# ATTACHMENT 10

## PLAN REVIEW COMMENTS FOR COFA-04-23-017894

Architect's response and supporting materials

REVISED FENCE DETAIL FROM 2/A202

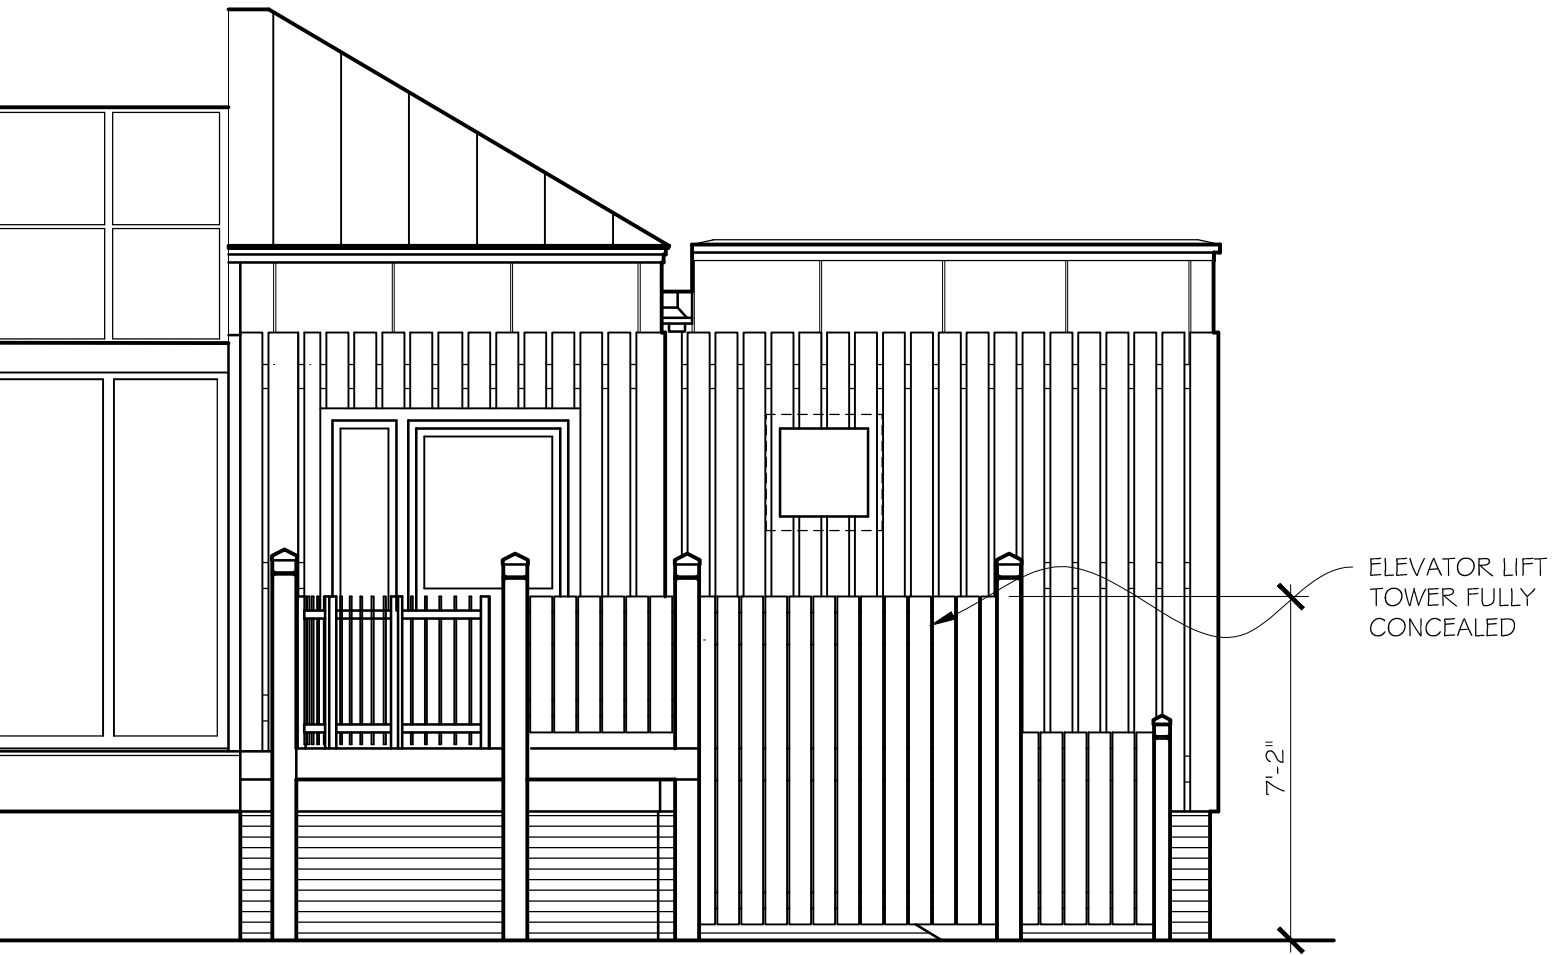
- Article 5 Comment 8: “Fences in rear and side yards may not exceed 6 feet in height”
  - Elevations have been revised to show 6’: 2/A202 – attached as 8.5x11 – See Page 15

- See Supplementary detail showing 7’2” fence intended to conceal wheelchair lift from view – attached as 8.5x11 – See Page 16
- HPRC (Glen Umberger)
  - Comment 2: “Detail 7/A401 shows a condition where two different materials are meeting at an outside corner”

**APEB52STRCOMLAR**

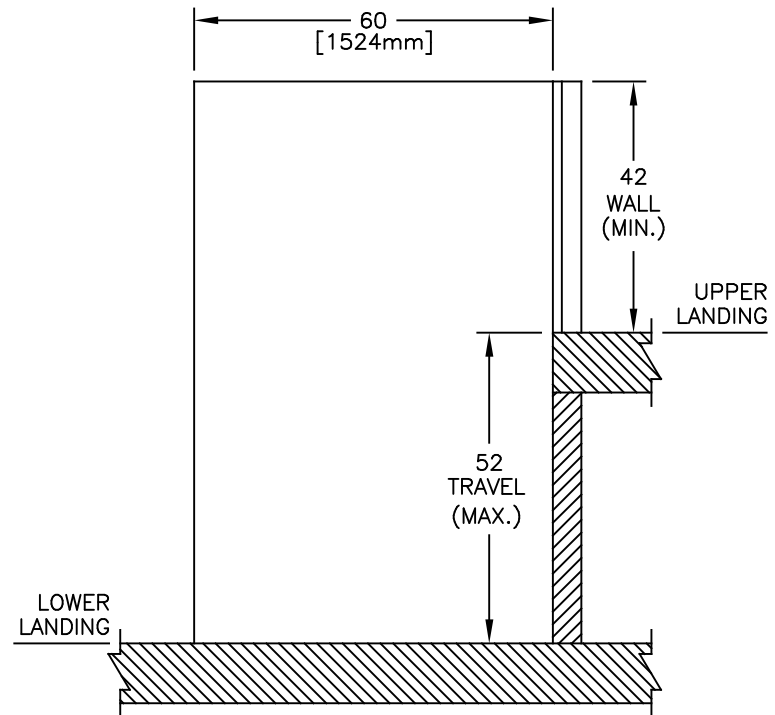
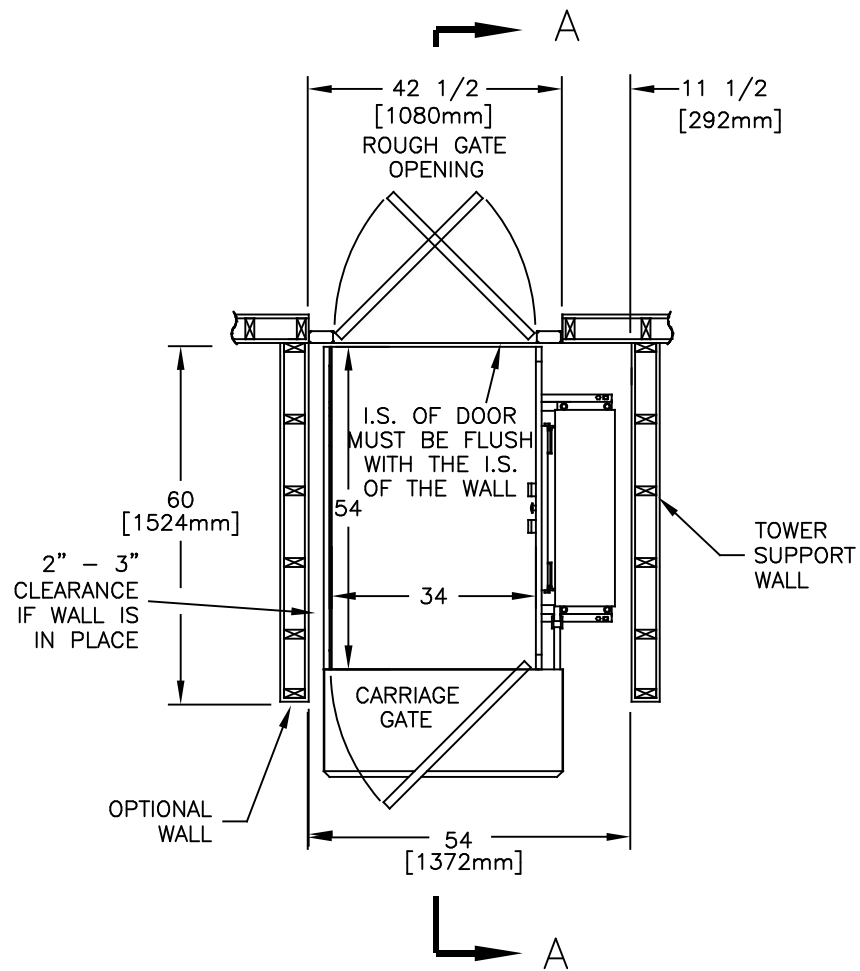
- Sheet SP101 has been removed from the permit set
- Additional requests:
  - Request to provide cut sheet for proposed wheelchair lift
    - Manufacturer cut sheet for Freedom Lift Systems model APEB52STRCOMLAR attached – See Page 20
